**IN THE DRAWINGS**

## REMARKS

FIG. 3

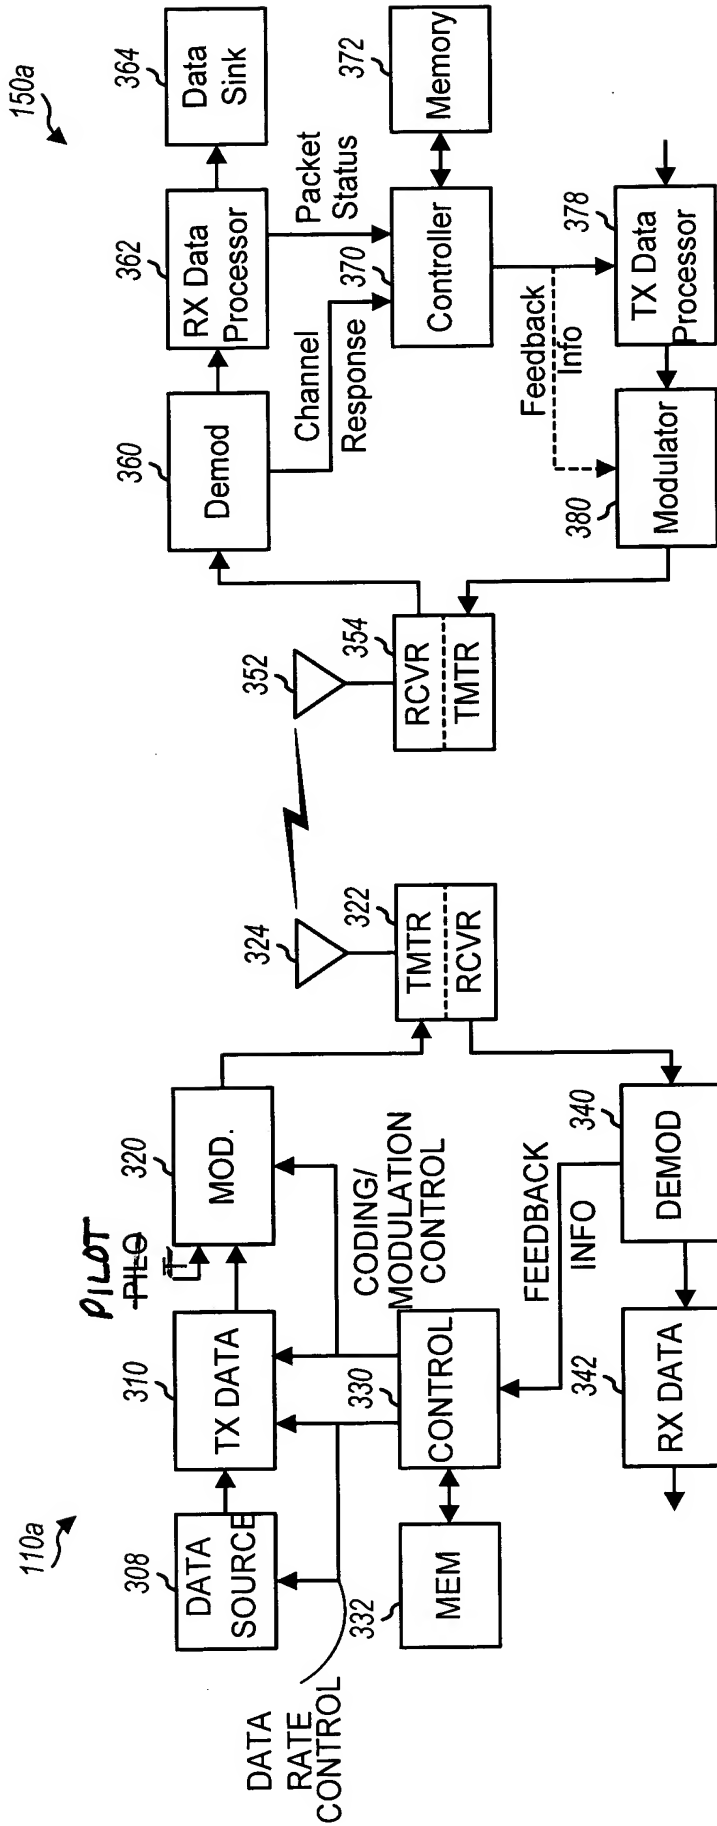
The attached sheets of drawings include changes to Figs. 3 and 5. These sheets, which include Figs. 3 and 5; respectively, replace the original sheets including Figs. 3 and 5, respectively. In Fig. 3, the word “pilot” (an input to block 320) has been put into concatenated form, as suggested by the Examiner. In Fig. 5, in block 524, the word “decoder” has been put into concatenated form, as suggested by the Examiner. Applicant thanks the Examiner for the helpful suggestions.
